The Exchange (P18-0091-0101, P18-0401 & P18-0424), Exhibit 9 - Applicant
Prepared Variance Justifications

Re: The Exchange Draft Environmental Impact Report

Re: Comment on the The Exchange aka P18-0091 (GP), P18-0092 (RZ), P18-0093(PPE), P18-0094-0098(CUP), P18-0101(DR), P18-0424 (GE), P18-0100 (MCUP) and P18-0401(EIR)

Re: **Response to Environmental Impact Report for The Exchange Project**

Exhibit 8-2 included in the Urban Crossroads TIA report dated November 30, 2018 (EIR Appendix L: Traffic Impact Assessment)

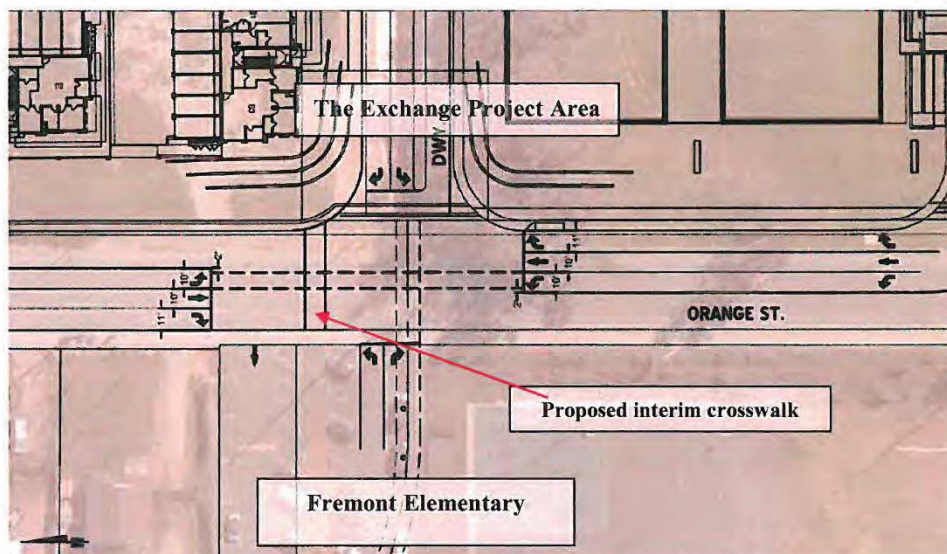
- a. The interim intersection layout has a proposed crosswalk aligning with the median of the existing Fremont parking lot. This will result in a significant safety hazard of students having to cross vehicle traffic on Orange Street and at either one of the two Fremont driveways to access the school's on-site walkways.

The interim layout, as proposed, does not comply with the Education or Mobility Elements of the City of Riverside General Plan 2025 for Safe Routes to Schools. City Policy CCM-8.2 is to promote walking and biking as a safe mode of travel for children attending local schools. CCM-8.3 is to apply traffic management

Exhibit 8-3, the “ultimate design” included in the Urban Crossroads TIA report dated November 30, 2018. Shows an alteration to Fremont’s parking lot that was never approved by RUSD.

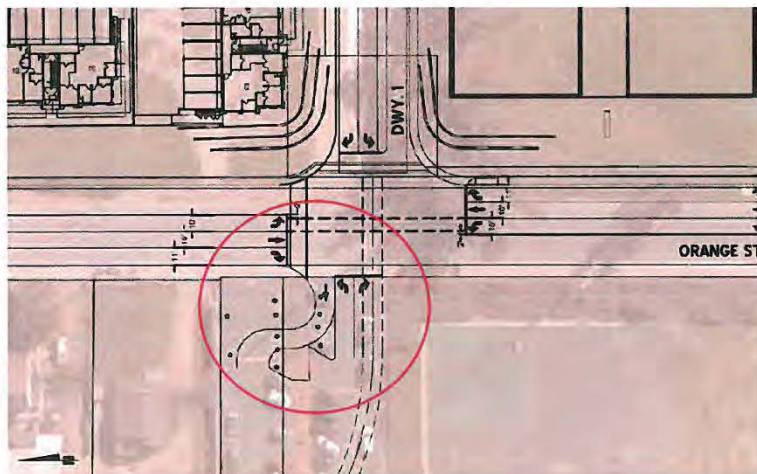
- c. Furthermore, the TIA analysis of Driveway 1 is invalid. The TIA concludes that there is no significant impact at Driveway 1, however, this conclusion is based on using the ultimate intersection layout. The ultimate intersection layout depicts an alteration of Fremont’s north driveway that was never approved by RUSD.

As stated in previous communications with the City and developer, this proposed driveway alteration must impose no financial responsibility to RUSD for the cost of the construction. RUSD has no plans to implement such a proposed alteration. It was RUSD's understanding that the ultimate layout would not be proposed to be implemented as part of the project. Therefore, is should not be utilized to conclude that the project will not have an impact. Any such proposed alteration must be planned and authorized with District Planning and Development staff prior to the Planning Commission meeting on March 21, 2019.

- d. The project, as proposed, will create a significant safety impact to pedestrians crossing Orange Street and conflict with the City's and District's responsibility to provide safe routes to schools. RUSD requests the following mitigation, at a minimum, to improve pedestrian safety at Driveway 1 and correct the EIR analysis.
